**L25N & L27N In-line Breakers**  
***Notification of Conditional Approval***  
**CAA ID Number: 2005-EX261**

**Expedited System Impact Assessment  
Hydro One Networks Inc.  
230 kV Circuits L25N and L27N – Addition of In-line Breakers at Petrosar Junction  
CAA ID Number: 2005-EX261**

Diagram 1 - Proposed L25N & L27N In-line Breakers

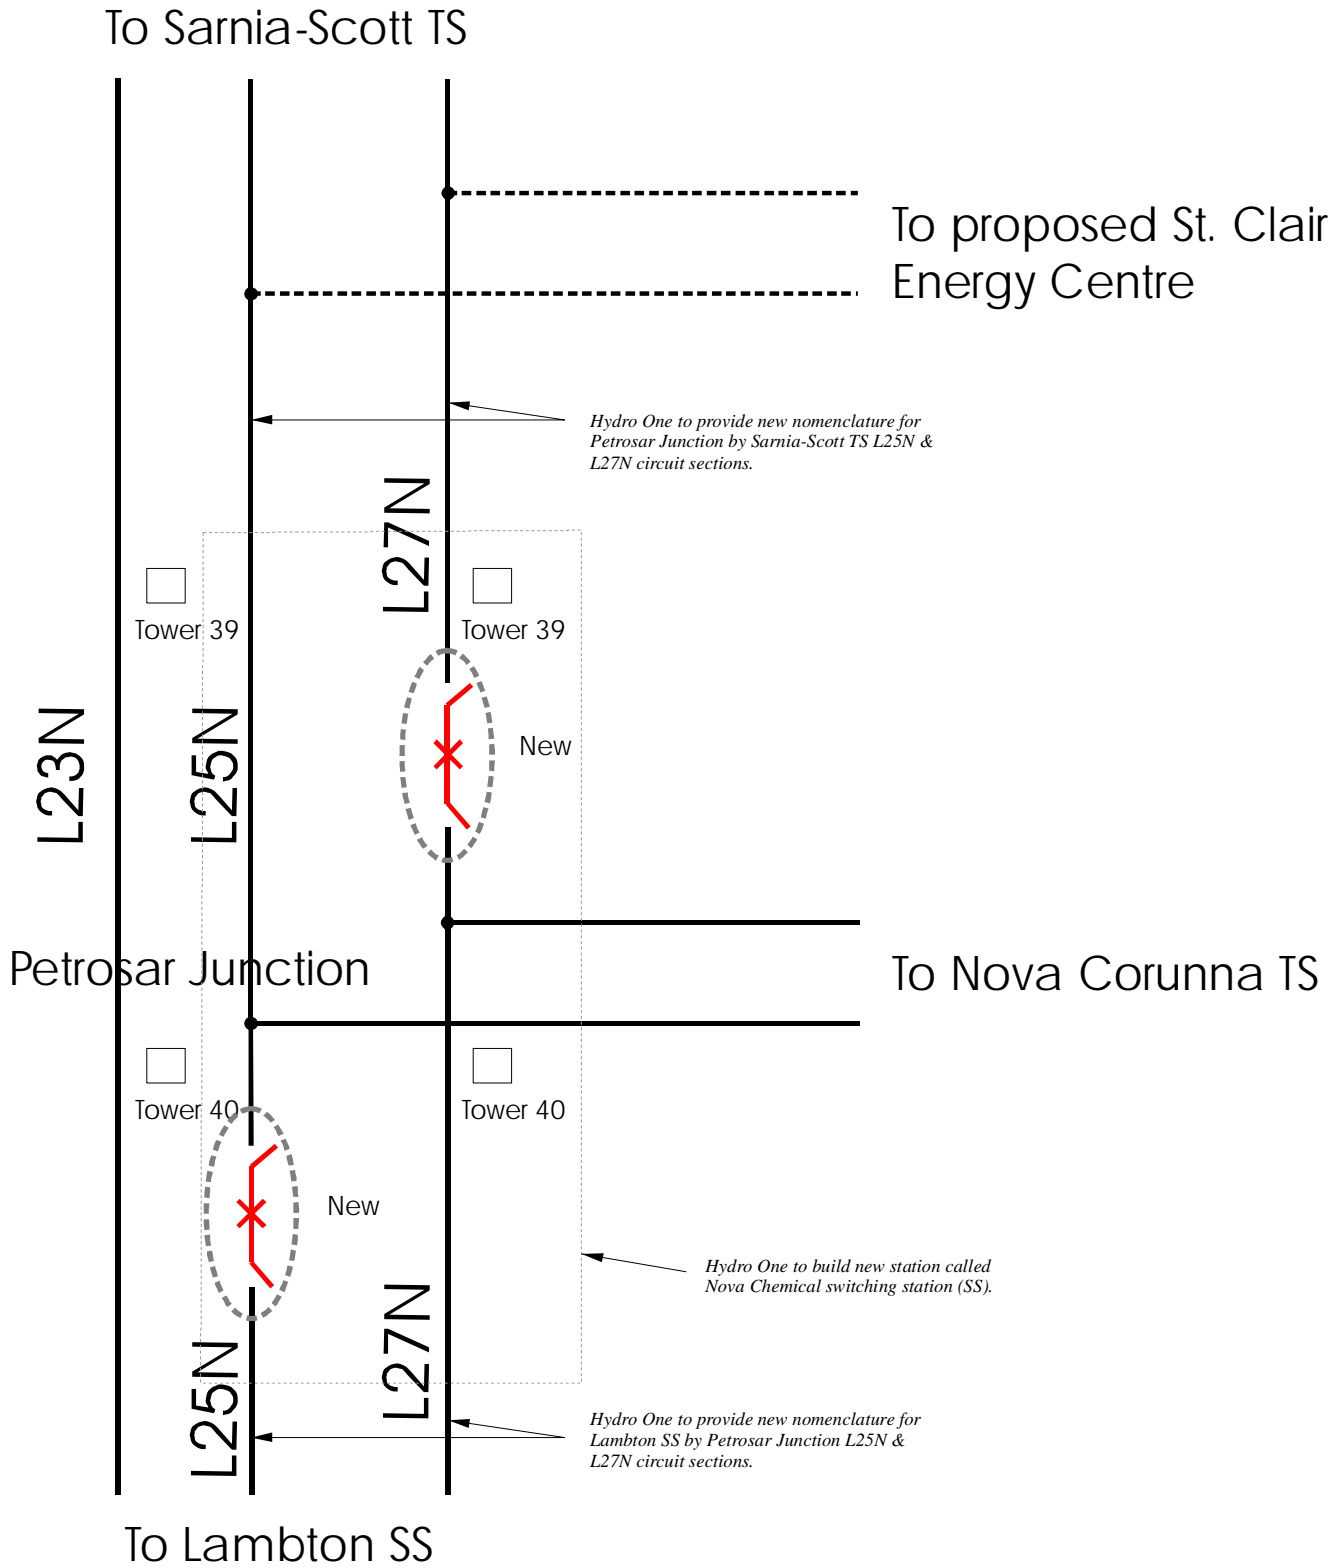
As shown in Diagram 1, one breaker is to be connected to the south of the Nova Corunna tap location on circuit L25N and the other breaker is to be connected to the north of the Nova Corunna tap location on circuit L27N.

The installation of in-line breakers and associated equipment near the Nova Corunna tap will split each existing 230 kV circuit L25N and L27N into two sections – one section from Petrosar Junction to Sarnia-Scott TS and the other section from Petrosar Junction to Lambton SS.

New protections will be installed at the Petrosar Junction and coordinated with the existing L25N and L27N protections at Lambton SS and Sarnia-Scott TS so that only faulted circuit sections are removed from service and non-faulted circuit sections remain in service.

**DIAGRAM 2**

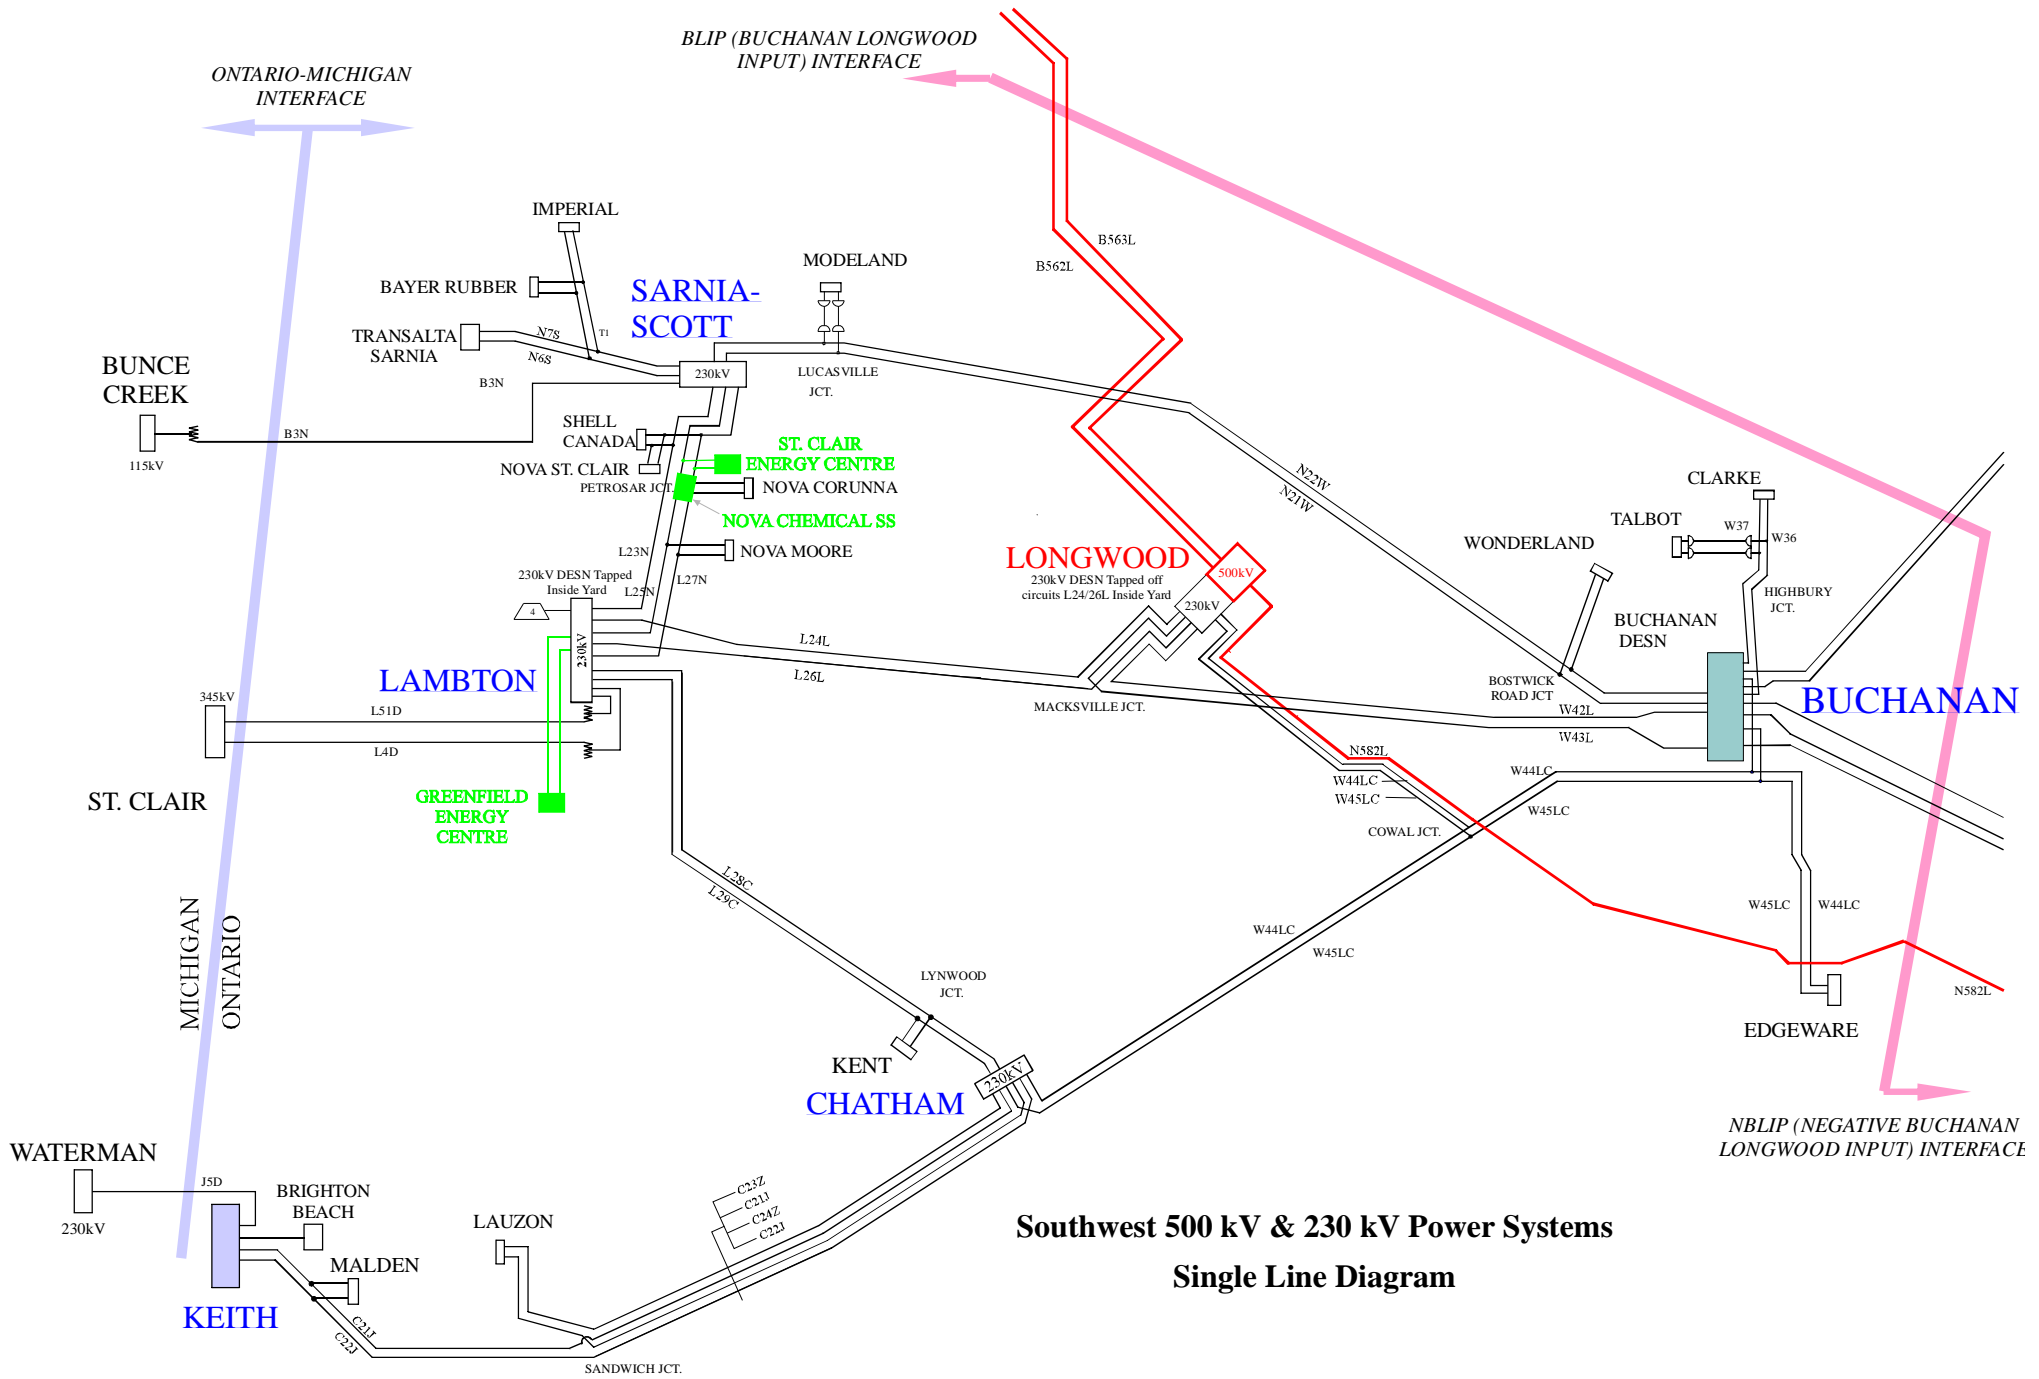
Diagram 2 is a single line diagram of the 500 kV and 230 kV power systems in southwest Ontario. In particular, the diagram shows the proposed locations of the Greenfield and St. Clair Energy Centres relative to the proposed location of Nova Chemical SS, and the locations of the various transmission customers connected to 230 kV circuits L23N, L25N and L27N, between Lambton SS and Sarnia-Scott TS.

DIAGRAM 4

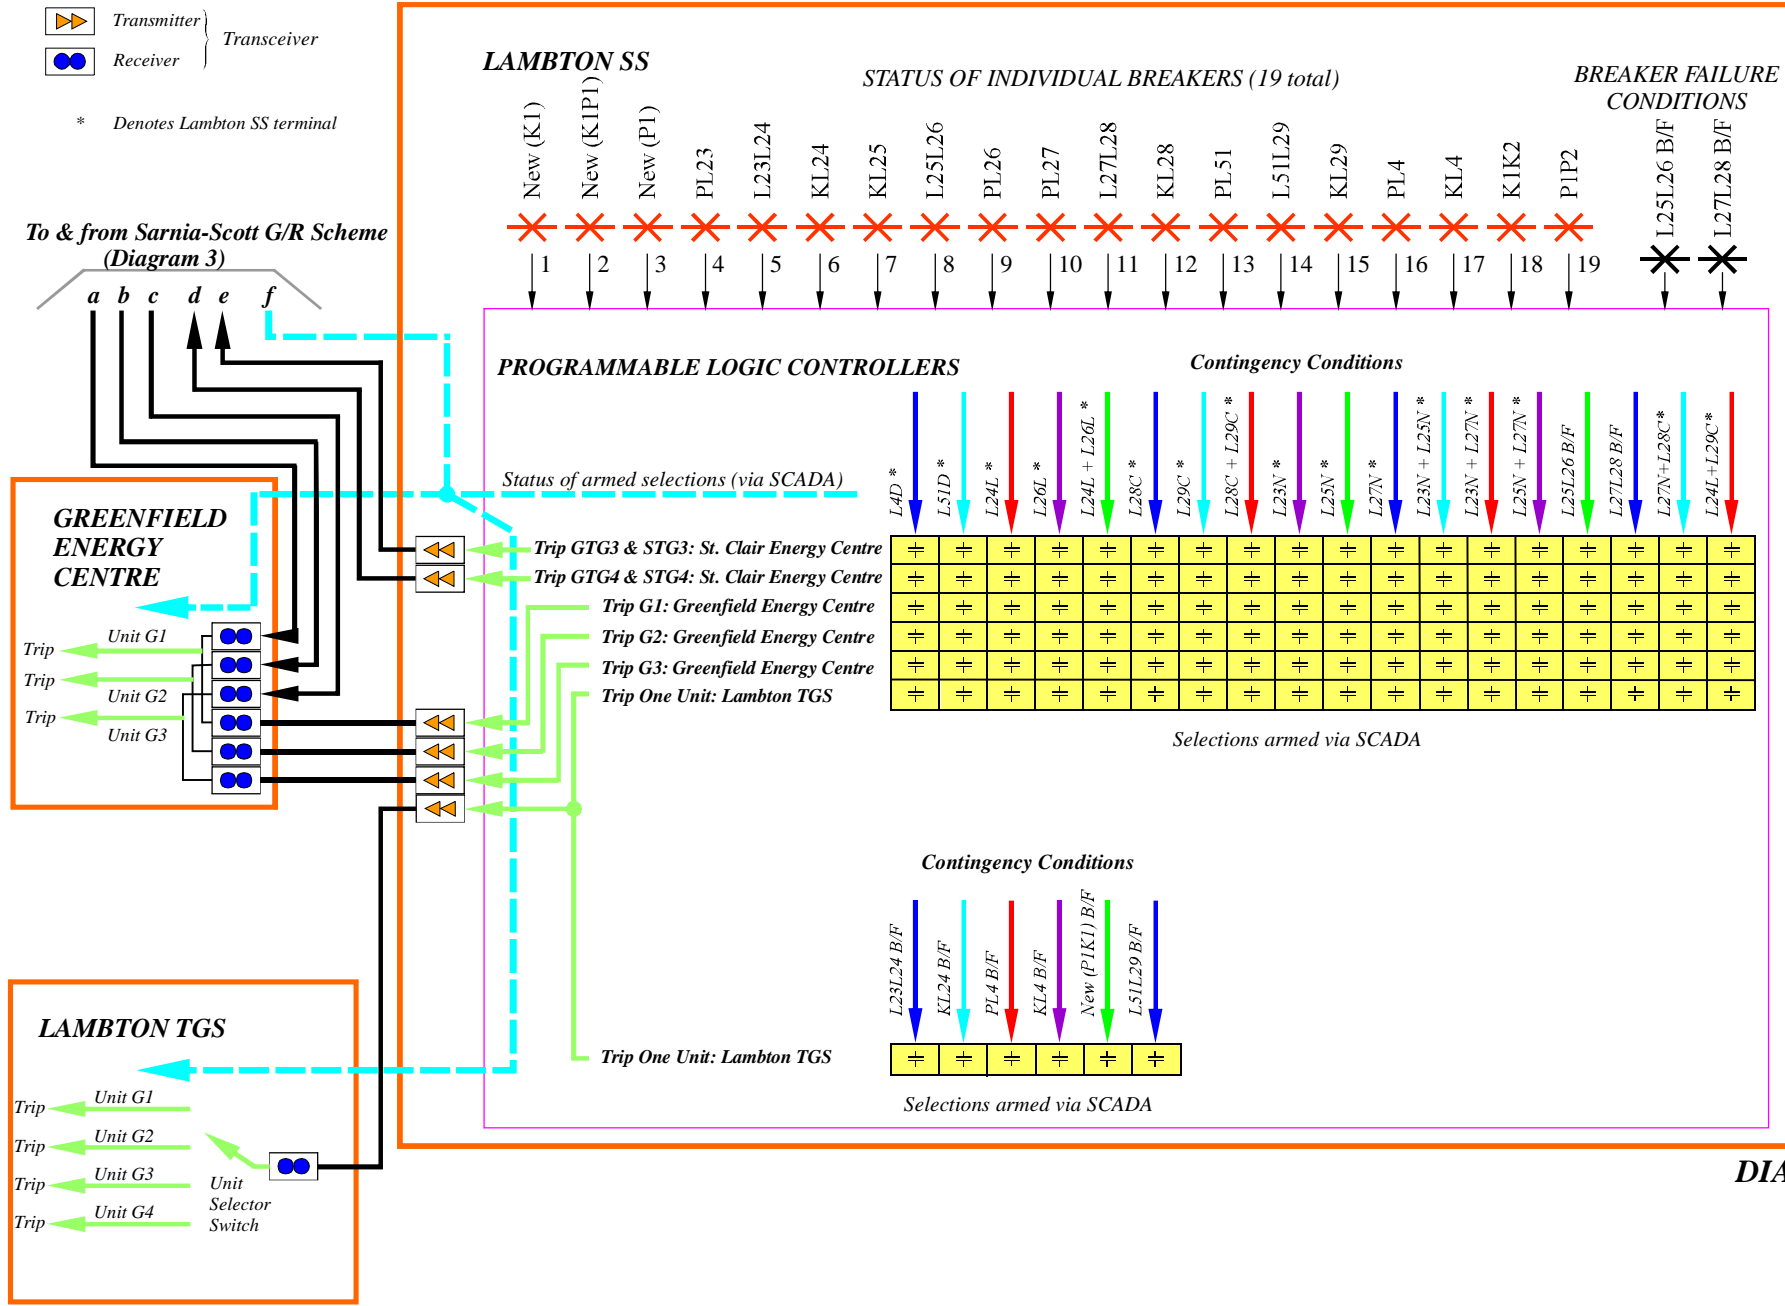
Diagrams 3 and 4 provide the overall functional specifications required for the existing Sarnia-Scott G/R Scheme and the new Lambton G/R Scheme, respectively, to incorporate the Greenfield and St. Clair Energy Centres. With the incorporation of the L25N and L27N in-line breakers, Hydro One must modify the Sarnia-Scott G/R Scheme to monitor for open conditions of these new breakers and to enable the pre-arming and tripping of Imperial Oil, TransAlta Sarnia, St. Clair and/or Greenfield, before the Greenfield Energy Centre or the St. Clair Energy Centre connect.

- Modify the existing Sarnia-Scott G/R Scheme for the capability to pre-arm and trip Imperial Oil, TransAlta Sarnia, St. Clair and/or Greenfield generation for breaker open conditions associated with the in-line breakers before the Greenfield Energy Centre or the St. Clair Energy Centre connect.
